**City of West Linn**  
**PRE-APPLICATION CONFERENCE MEETING**  
**February 14, 2013**

SUBJECT: 3-lot minor partition at 960 Dollar Street.

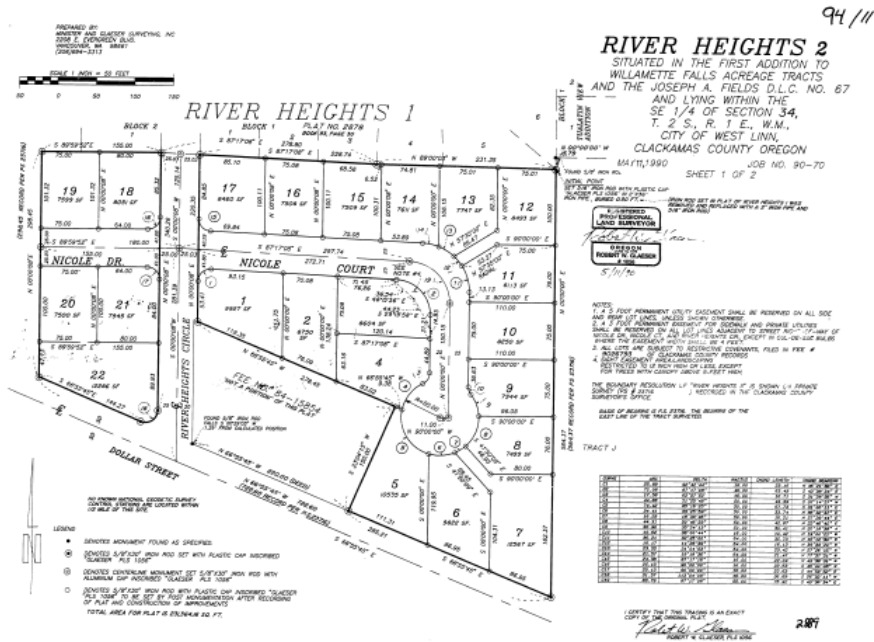
The applicant will need to prepare a tree survey of the property, indicating location, size, and species of each tree on the site. Each tree needs to be tagged in the field with a number that corresponds to the tree inventory map. The City Arborist will then determine which trees are significant. CDC Section 55.100(B)(2) requires that up to 20% of the relatively flatter non-type I and II lands shall be set aside to protect the “dripline plus 10 feet” of significant trees. That requirement can have an impact on this application. The applicant explained that any lot division and footprint of future homes will probably conflict with at least some of these trees. The applicant proposed mitigation for these trees.

Since there is no street grading associated with this project and certainly not in the interior of the proposed lots the opportunity to use mitigation is not available.

Recent land use applications that involved mitigation were for trees that were to be removed in excess of the “20 percent set aside”. The applicant must therefore protect up to 20 percent of the development site if there are enough qualifying significant trees to cover that much area or apply for a Class II Variance (Planning Commission).

Note: Preliminary site analysis by the City Arborist identified only one tree that may be significant. This will have to be confirmed after a complete tree inventory provided by the applicant.

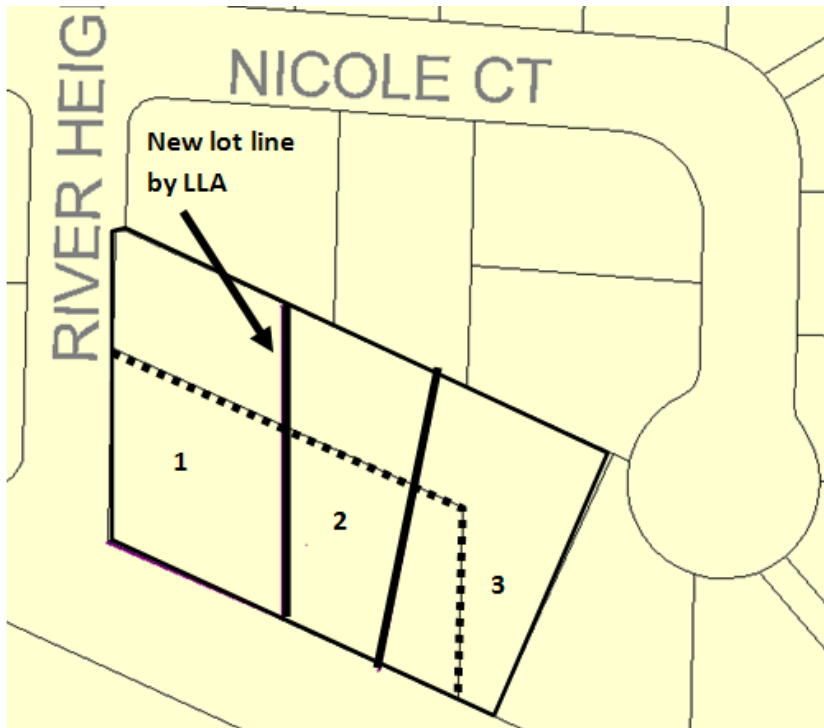
Assuming the two lots were correctly established, the applicant could use a lot line adjustment to shift the existing lot line so that one lot (lot 1) would occupy the west 132 feet and the other lot would occupy the east 146 feet (as measured along the north property line). The applicant would then be able to apply for building permits on the two re-aligned lots (once the existing house is removed) and subsequently apply for a minor partition to divide the east 146 feet in half to yield two lots (lots 2 and 3) for a total of three lots. (Prior to recording the MIP plat, the existing house must be demolished.)

If the two lots are not platted lots of record then the application would be limited to a minor partition.

The dashed line is the existing tax lot line that could be moved by lot line adjustment (LLA) to create a new lot line and lot 1 on the west edge of the site. Once the LLA is final the eastern portion of the site could then be minor partitioned into lots 2 and 3.

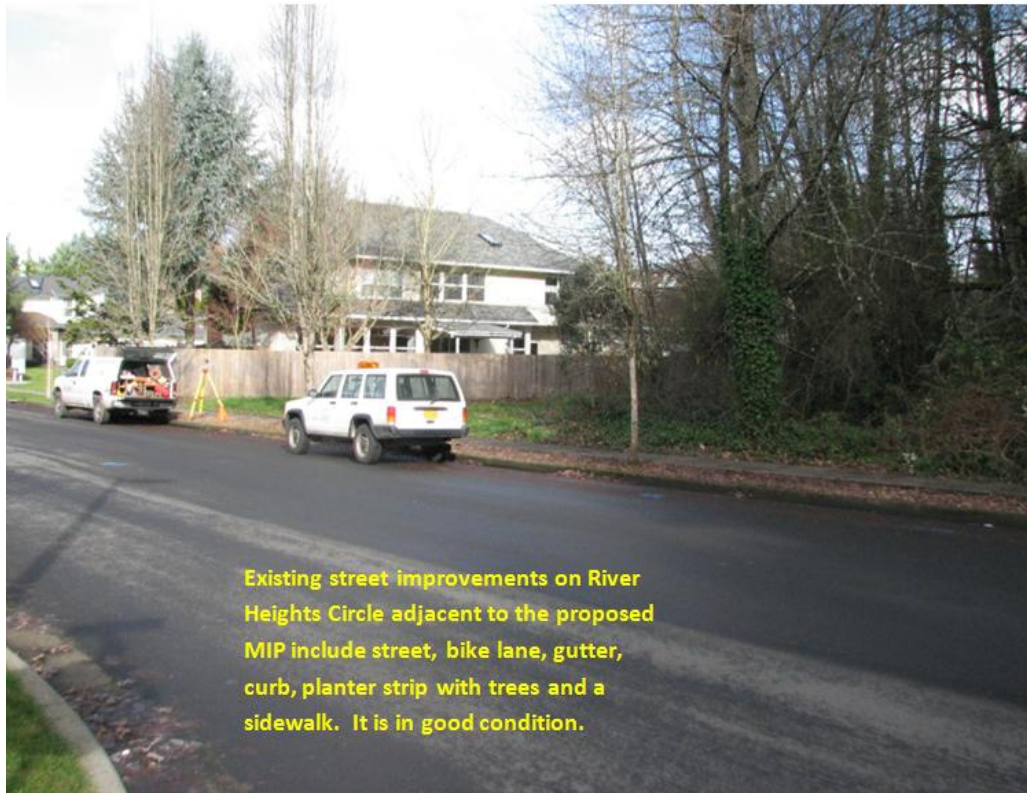
Dollar Street is a Collector according to the Transportation System Plan (TSP). There is a 60 foot ROW on Dollar Street which is sufficient. Half street improvements were installed by the developer of River Heights subdivision for the frontage of this property since it represented the entry point to the subdivision and the developer felt that an attractive entryway and street section was important to the marketability of the subdivision. The existing street improvements on Dollar Street includes a travel lane, bike lane, curb, three foot wide planter strip (with no street trees) and a five foot wide sidewalk. The condition of the street, curb and sidewalk appears good. (See Engineering comments below.)

River Heights Circle (below) is a local street. The ROW is 45 feet which is below the width in the adjacent subdivision and the width prescribed by the TSP (see Engineering comments below). On River Heights Circle existing street improvements include travel lane, curb, four foot wide planter strip with street trees and a four foot wide sidewalk.

#### H. WILLAMETTE PRESSURE ZONE MASTER PROJECT LIST

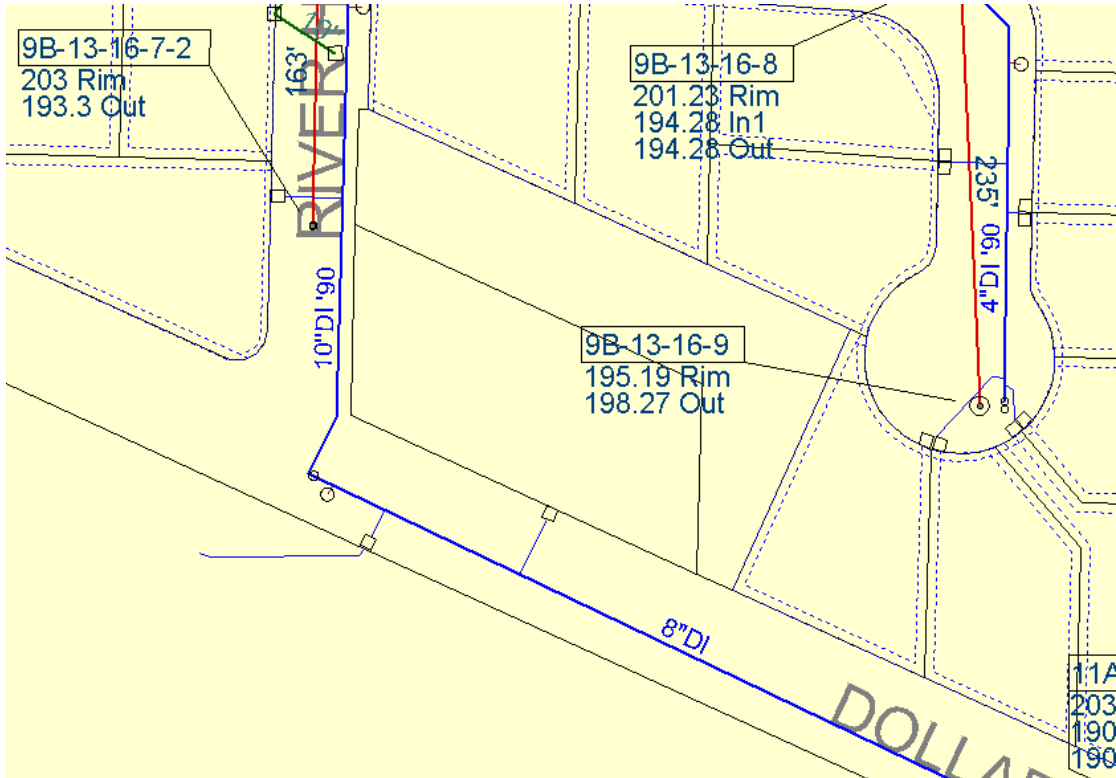
1. There are 34 water improvement projects listed in the City Water System Plan under the Willamette Pressure zone. However none of them is along the subject development frontage. Thus there is no improvement required along the proposed project frontage.
